Subject: Subdivision Application No. 20180001
13-Lot Residential Subdivision
901 Little Shiloh Road

Re: Preliminary/Final Subdivision - 901 Little Shiloh Road

# SD-01-18-15244 - West Goshen Township

Site Plan Detail, Sheet 2: Preliminary/Final Subdivision - 901 Little Shiloh Road

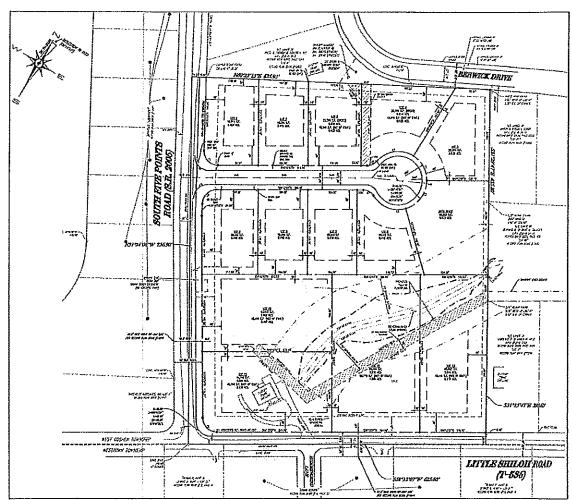
3. For clarity purposes, the applicant should identify on the site plan which existing building(s) will be removed. This information is not provided on the current plan submission.

4. The 2013 Township Historic Resource Atlas identifies the project site contains a Class II Historic Resource. Although not required, we suggest that the Township reserve granting final plan approval until the proposal has been reviewed by the Township's Historical Commission. For clarity purposes, the applicant should identify why the existing building on proposed Lot 11 will remain while the residence and other buildings on the northern portion of the project site will apparently be demolished.

- 5. We suggest that the applicant and the Township consider the use of a shared driveway entrance for Lots 12 and 13. Shared driveways can reduce the number of new access points on public roads, limit impervious coverage, reduce earth disturbance and lower construction costs.
- 6. We suggest that the applicant provide sidewalks for this development, particularly on the Road A cul-de-sac. Sidewalks are an essential design element for new construction in the Suburban Landscape.
